Public Input No. 2120-NFPA 70-2020 [Article 100]

430.1 Scope.

Figure 430.1 Article 430 Contents.

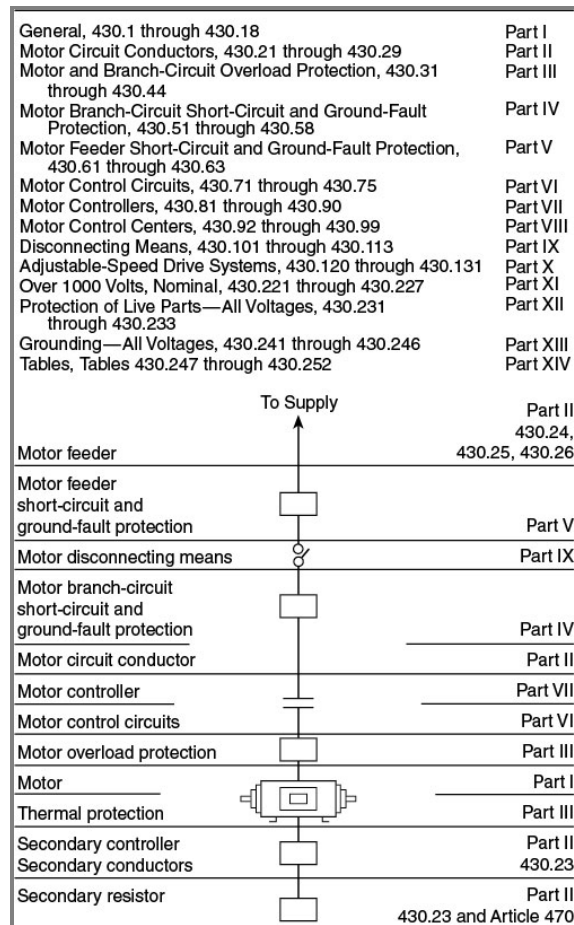
In 'Figure 430.1' there is essentially a 1-line diagram for a motor circuit. This diagram should say "From Supply" with the 'arrow' pointing toward the End Use Equipment. Everywhere else in the NEC the source of a circuit is the OCPD or separately derived system. In a logic diagram you go 'FROM the Supply Source' out 'TO End use equipment and devices'. In this case, the end use equipment happens to be a MOTOR, not a circuit originating from the motor.

Resolution: Submitter did not provide a statement on how this PI will improves safety or usability. The change would not improve clarity or readability. The arrow is shown to indicate the location of the power supply not the direction of power flow.

Figure 430.1 Article 430 Contents.

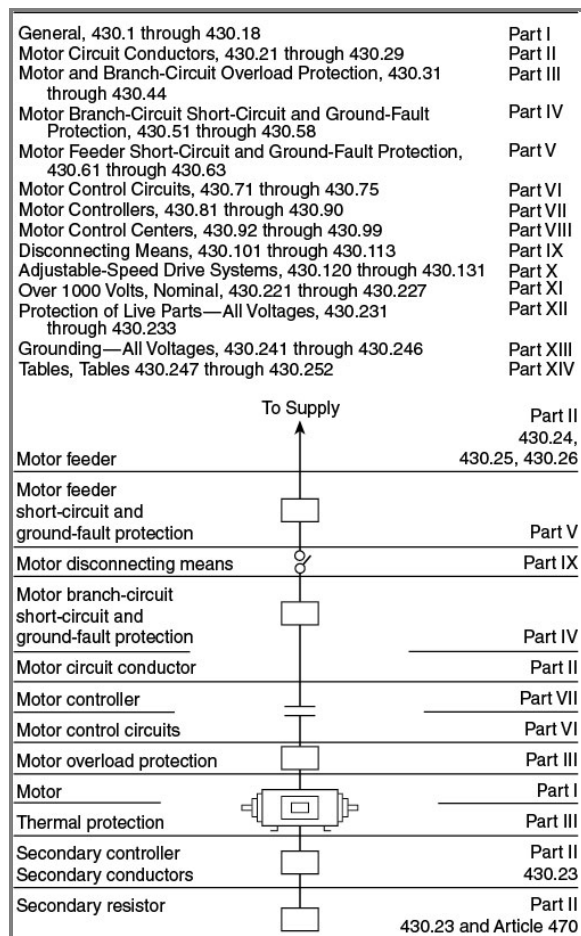
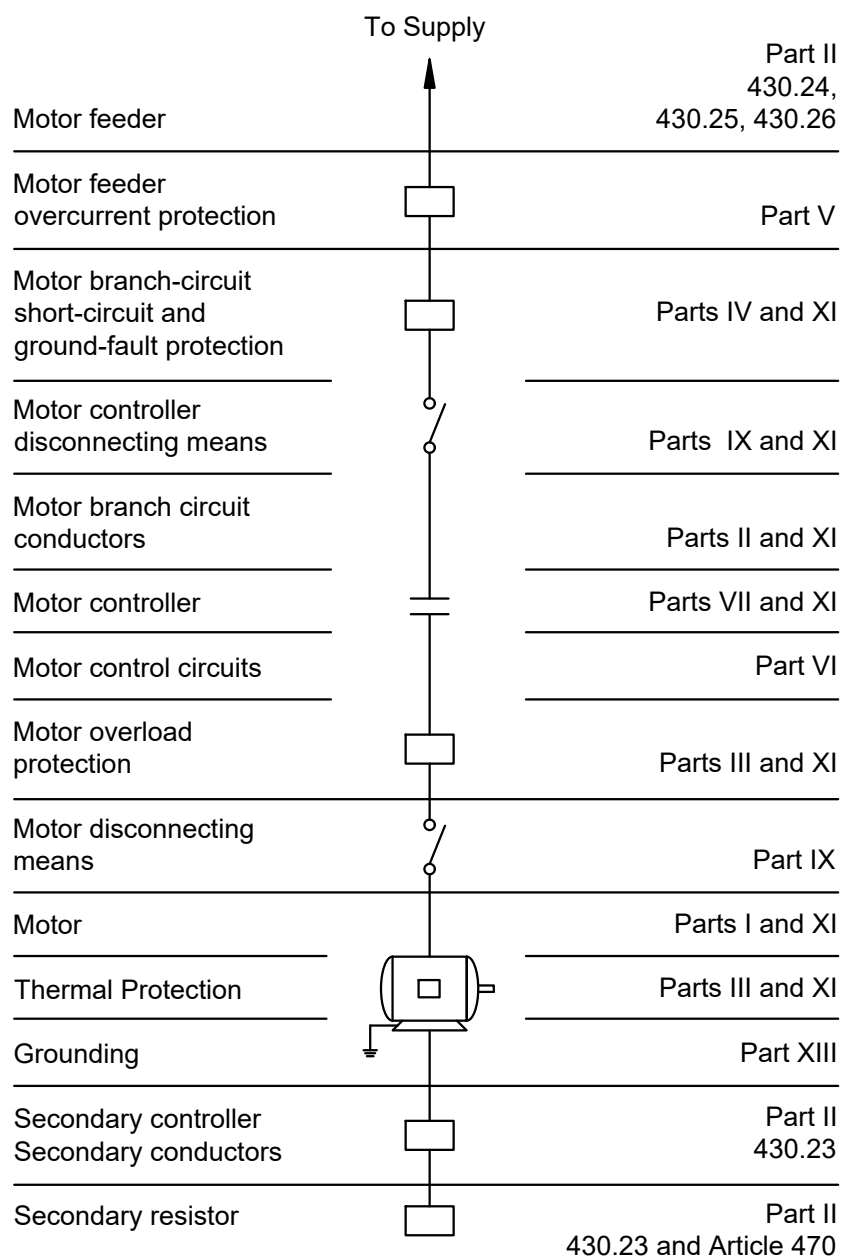
Delete existing Figure 430.1 and insert revised Figure 430.1 here. (see attached PDF file)

Existing Figure 430.1 single line diagram has several issues that are corrected with the proposed diagram.

2. The motor disconnecting means is in the wrong place in the circuit
3. Revised motor circuit conductors to motor branch circuit conductors
4. Added reference for motor grounding to diagram

Resolution: [FR-8030-NFPA 70-2020](#)
Statement: Figure is revised for usability and clarity. The figure was revised to include references to grounding, MV applications, adjustable-speed drive systems, as well as other motor circuit information.
